Item No. 13.1.1
North West Community Council
April 8, 2019

DATE: March 7, 2019

SUBJECT: **Case 18276: Development Agreement for 74 Union Street, Bedford**

PROJECT: **UNION COURTYARD
OPTION B**

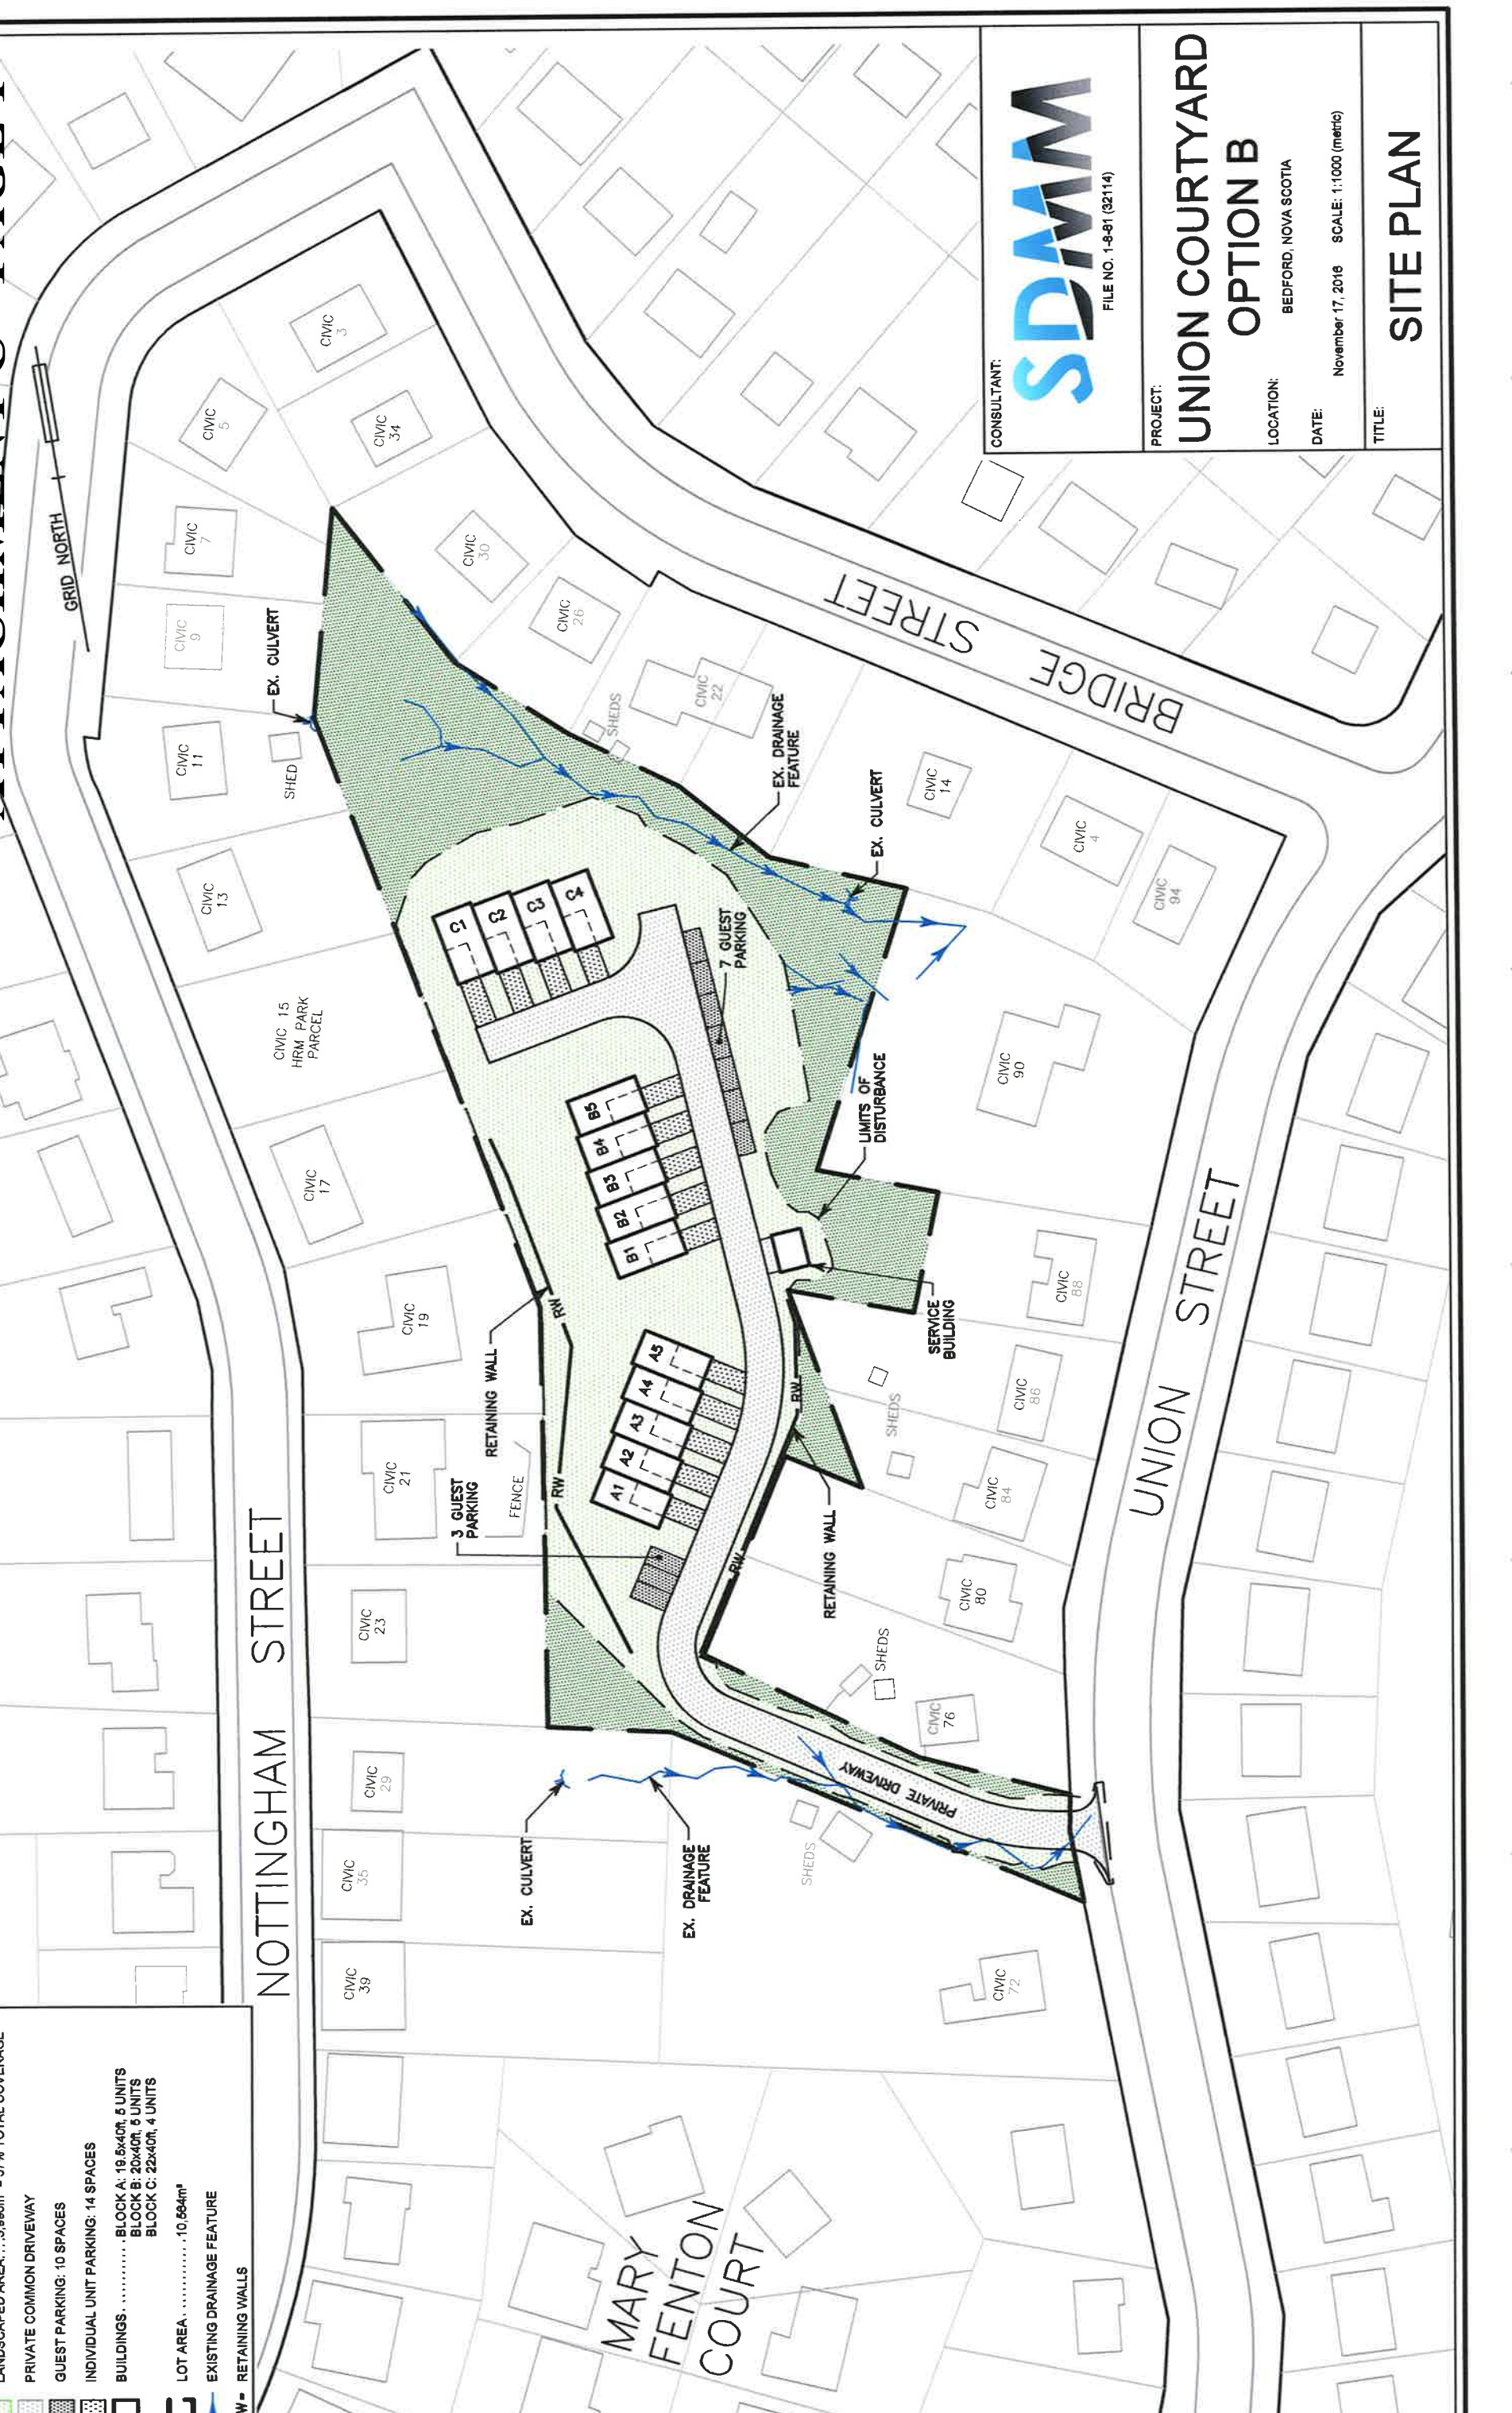
Member #5 - There is a concern regarding the storage of snow once cleared from the streets. Given the proposed layout of the development and the configuration of the roadways (particularly in Plan B) the natural tendency would be to push the snow off the roadway and down the embankment at the edge of the roadway on the northern side of the property. A buildup of snow in one area over the course of the winter can lead to excessive amounts of snow melt and runoff in that area during the spring melt particularly when coinciding with any heavy rainfall events. This concern can be addressed in the development agreement by assuring that barriers (natural or man made) exist to prevent this practice. The placement of barriers will also help to address excessive noise and light pollution from vehicles. Removal of excessive snow amounts offsite would be the preferred method of mitigation.
